FOUNDATION CONDITIONS
MADAWASKA RIVER BRIDGE
HIGHWAY NO. 515; W.P. 253-62
JEWELLEVILLE, ONTARIO

Foundation Conditions
Madawaska River Bridge
Highway No. 515; W.P. 253-62
Jewelleville, Ontario

W.P. 253-62 - Site 29-92 - Madawaska River Bridge,
Jewelville, Hwy. 515, District 10 (Bangorft).

DEPARTMENT OF HIGHWAYS ONTARIO BRIDGE DIVISION			
MADAWASKA RIVER BRIDGE AT JEWELLVILLE			
KING'S HIGHWAY No. 515		DIST. No. 10	
CO. RENFREW		CON. XVIII	
TWP. RAGLAN		LOT 23+24	
PRELIMINARY			
APPROVED		SITE No. 29-92	
DESIGN		W.P. No. 253-62	
DRAWING		CONTRACT	
DATE		DRAWING	
JULY 1966		D-5792-P1

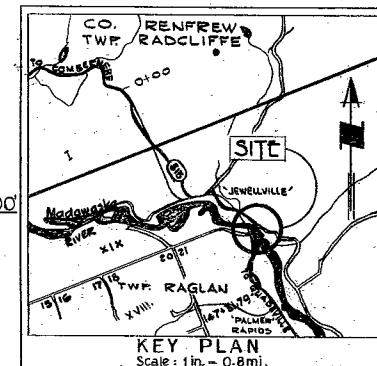
The steel H-piles (12 BP 74) for the south pier are shown to have "Oslo" points. In view of the subsoil conditions at this site, layer of sand and gravel with cobbles and boulders, and the relatively small dip in the bedrock surface, we feel that the use of "Oslo" points is not warranted.

Because of the possibility that the piles may encounter boulders, persistent hard driving will be necessary. This, of course, is inconsistent with the driving of piles with the "Oslo" point. We would recommend that the pile tip be rather, reinforced as per present D.H.O. standards. The rock penetration of such piles, in our opinion, will be adequate.

We would also suggest that the subsoil description on the drawing be changed to conform with the description given in the foundation report.

We would also like to question whether the 0.25" wall thickness of the 24" steel tube piles is necessary. These piles are to be filled with concrete, and we therefore feel that a thinner wall thickness would suffice.
